**HIGH STREET, SANDY  
CENTRAL BEDFORDSHIRE**

**PROPOSED ZEBRA CROSSING**

**COMBINED STAGE 1&2 ROAD SAFETY AUDIT**

Dated	19 <sup>th</sup> November 2021
Registration Code:	8704
RJ HUB:	12213101190300014
DM Ref:	N/A

# 7.0 COMBINED STAGE 1&2 ROAD SAFETY AUDIT – PROBLEM LOCATION PLAN

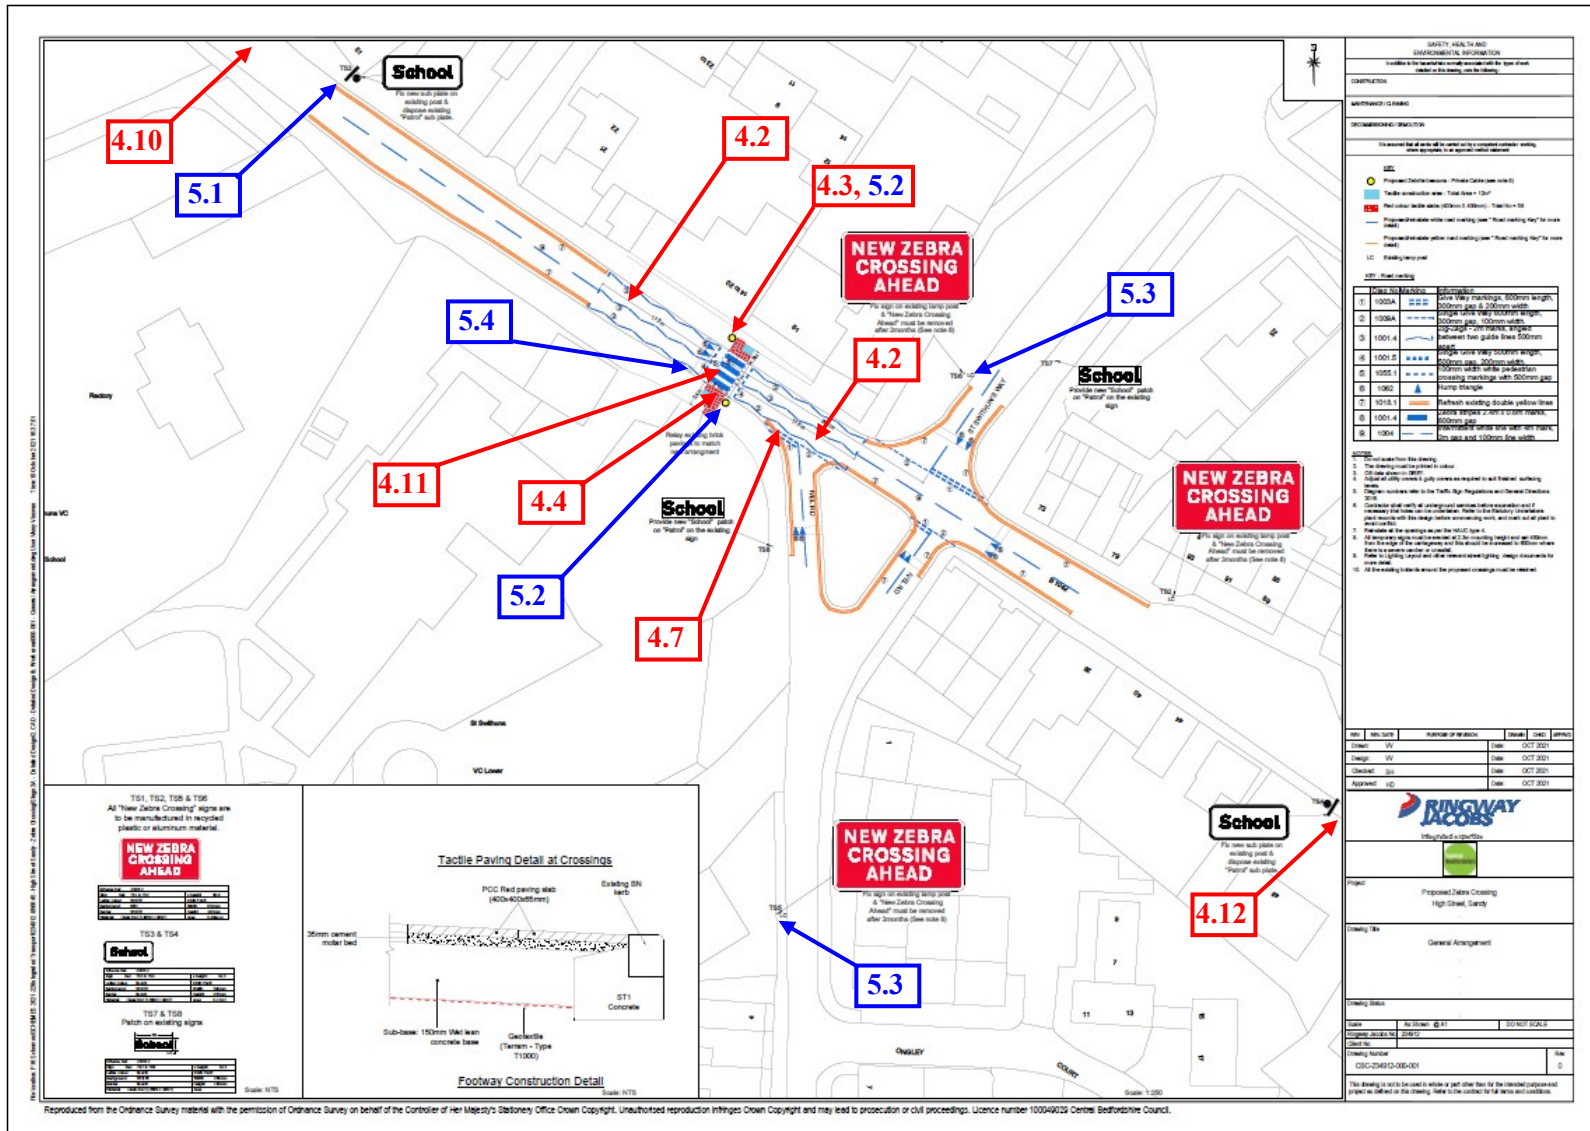
Additional Note 5.5 applies to the extents of the scheme
